# Access Compliance Report

## Public Rights-of-Way

### (Curb Ramps)

Intersection ID: 1002943	Main Street: CRAWFORD_BROOK_LN	Cross Street: N/A	Location: SE
ADA ID: A6DAE55DC93B	Ramp Type: BlendTrans1	Initial Pass/Fail: Fail	Overall Compliance: No
			Severity Score: 21.25

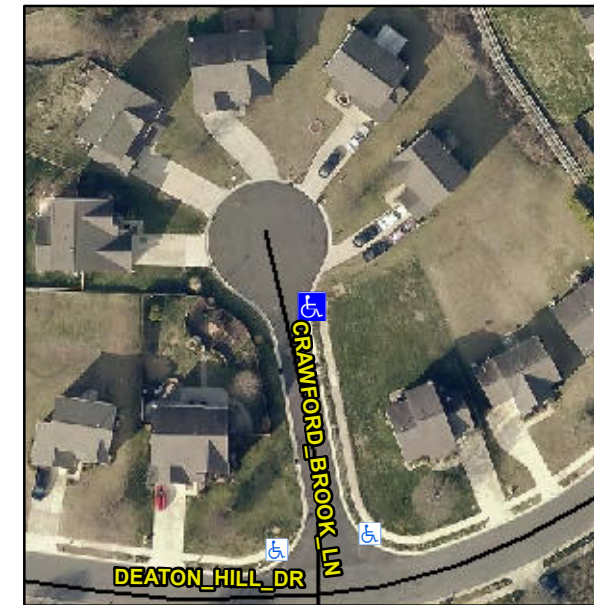
**DAMAGED DWS**

**Not Found, R304.5.1, R304.5.3**

**Remove & Replace Curb Ramp With Two New Directional Ramps or Equivalent.**
